**La Jolla Shores Planned District Advisory Board (LJSPDAB)
APPLICANT PROJECT INFORMATION FORM**

- Project Tracking System (PTS) Number/Accela "PRJ" Number and Project Name (only submitted projects to the Development Services Department can be heard as action items):
PRJ-1116561: FRESCOTA RESIDENCE

- Address and APN(s):
2175 & 2177 CALLE FRESCOTA, SAN DIEGO, CA 92037: 346-222-04-00

Building Construction Plans PRJ-1116561.pdf

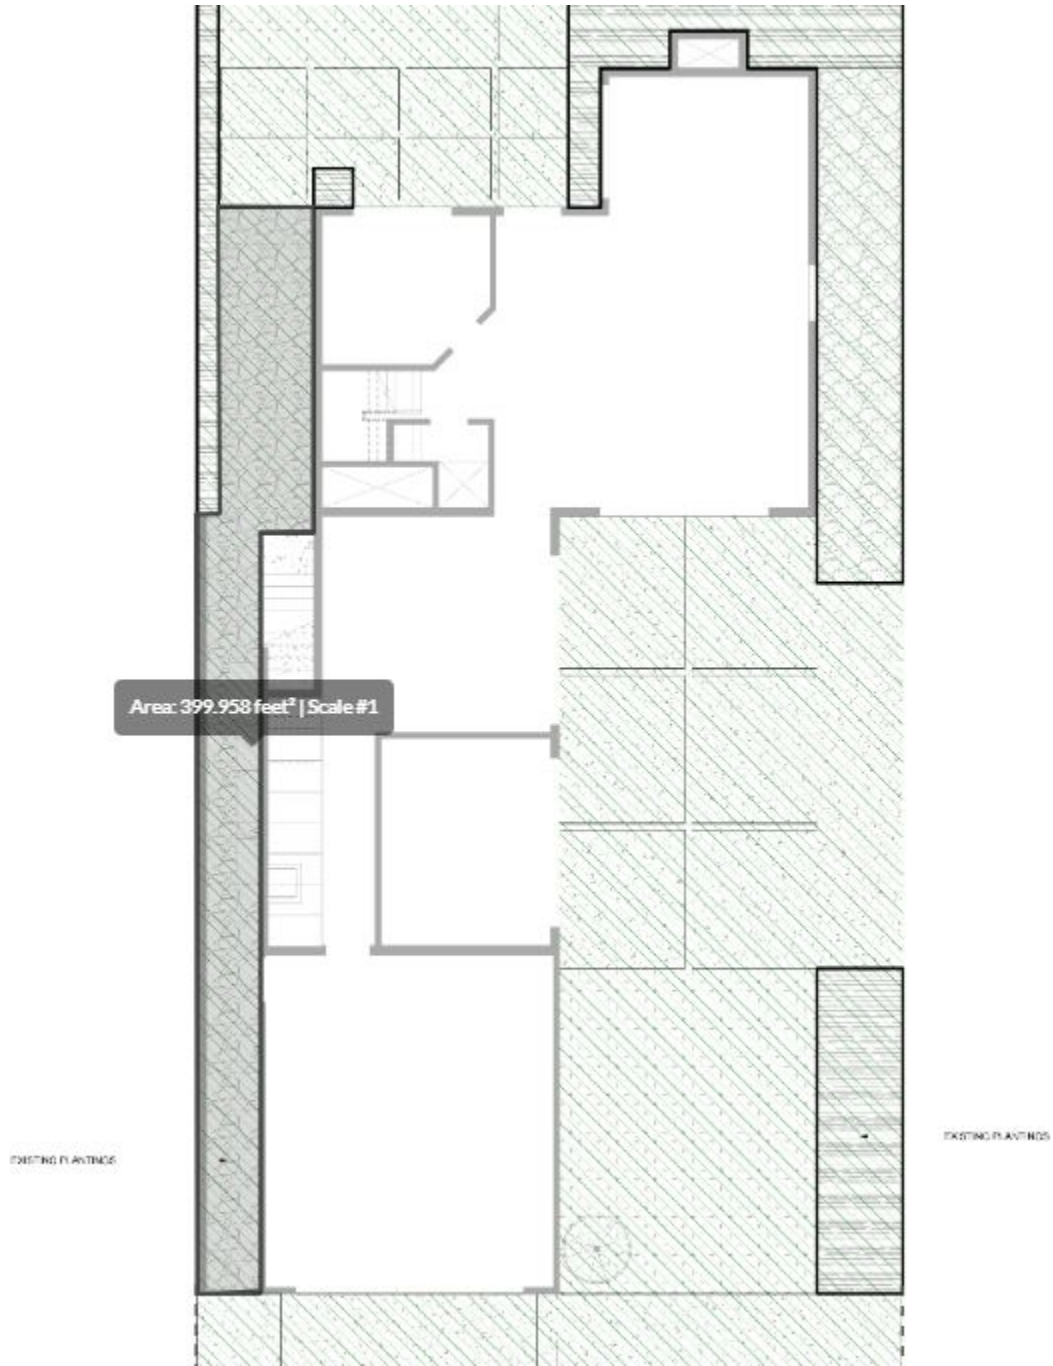
[Comment 00063 | Page | Open]

Landscape Are Diagram – 2nd Review: Satellite imagery shows the west end of the property is an existing walkway and not existing plantings. Please note that walkways do not count toward landscape requirements, §1510.0304(h)(1).
